# PERMIT

SEWAGE DISPOSAL SYSTEM

MARYLAND STATE DEPARTMENT OF HEALTH

ADDRESS 6161 Meadowridge Road, Elkridge, Md.

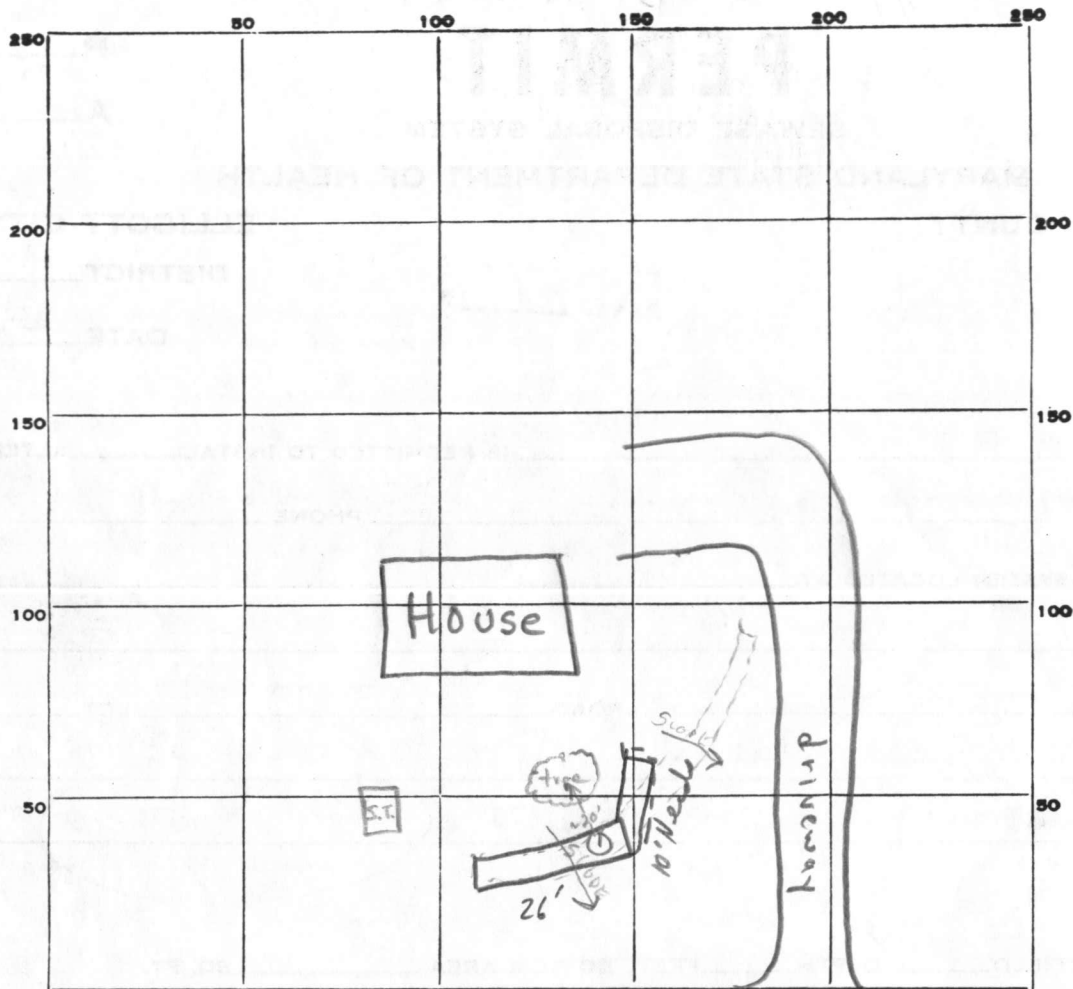
5/13/77 Partial  
see back  
verify  
last 10'  
+ trench  
12' deep

OTHER REPAIR - Call for inspection when ground is opened up and Sanitarian will

recommend repair system. → minimum 350 sq. ft. sidewall area in trench, 5'

~60' long; max depth 12' see comment on reverse side P.S.

REMARKS 5/12/77 Hole dug 12' deep; ~4-5' clay soil; sandy below. Recommend trench ~60' long = 6' gravel under pipe. Location as shown in above sketch F.S.

partial 5/13/77 Note cavity in - sandy on trench 35' because first 26' is 4'+ in most places - 12' deep. Note to call on permit if changed from A.M.; owner Mr. Wade to confirm last 10' + 12' depth.
